Evaluation of Stage I Vapor Recovery Components, OPW 1-3700 Series Spill Containers

Subject: Request to add Stage I Vapor Recovery Components, 1-3700 Series

List of changes between 1-3100 series and 1-3700 series products

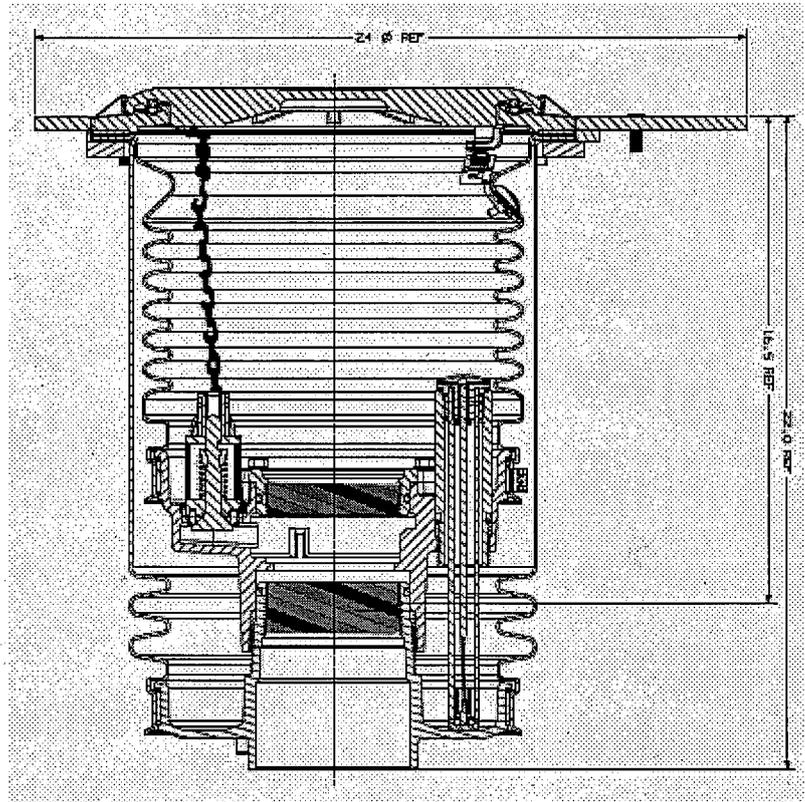
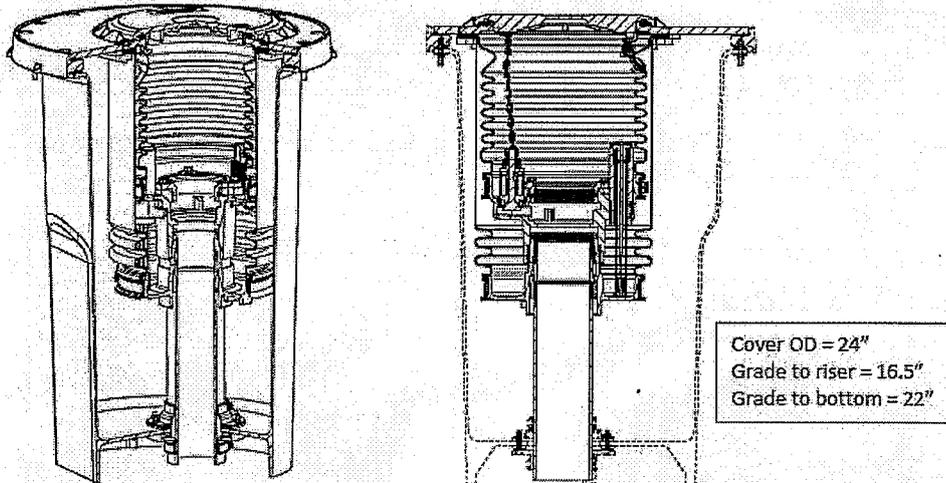
- Same bases, drain valve, plug, float gauge, sensors, flange adaptor, bellows, snowplow ring, and cover used in all models.
- Same options are available on both models: double wall, single wall, float gauge, sensor, sealable cover, raintight cover.
- 1-3700 series have a steel main cover. 1-3100 series have a ductile iron mounting ring.
- 1-3700 series does not include a guard and skirt as the existing 500L or 700L fiberglass bucket performs this function.
